To: All FASTRON customer

PCN No: 000224

Concerning Part Name : 14HVP and 14HVP/T

Product Type : Pluggable Inductor

a) 14HVP- 471X / 561X / 681X / 821X /102X models

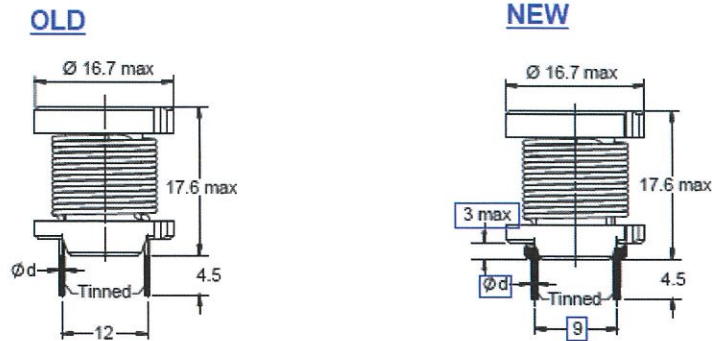
Description of Change : To revise the component dimensions as per the following drawings:

Notes :
a) 471X, $\varnothing d = 0.52\text{mm}$
b) 561X to 102X, $\varnothing d = 0.48$

Note :
 $\varnothing d = 0.80\text{mm}$

b) 14HVP/T- 471X / 561X / 681X / 821X /102X models

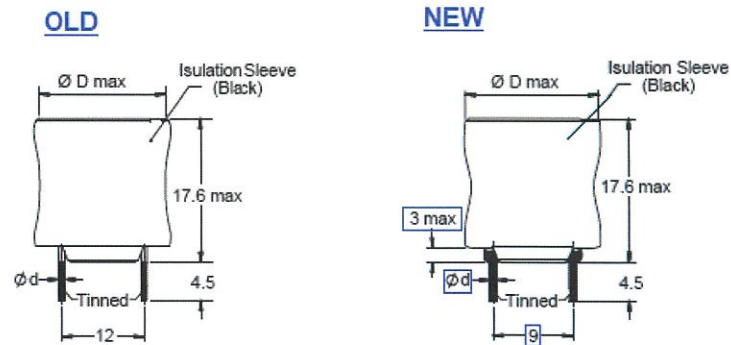
Notes :
a) 471X, $\varnothing d = 0.52\text{mm}$
b) 561X to 102X, $\varnothing d = 0.48$

Reason of Change : To improve the robustness of the leads.

Note :
 $\varnothing d = 0.80\text{mm}$
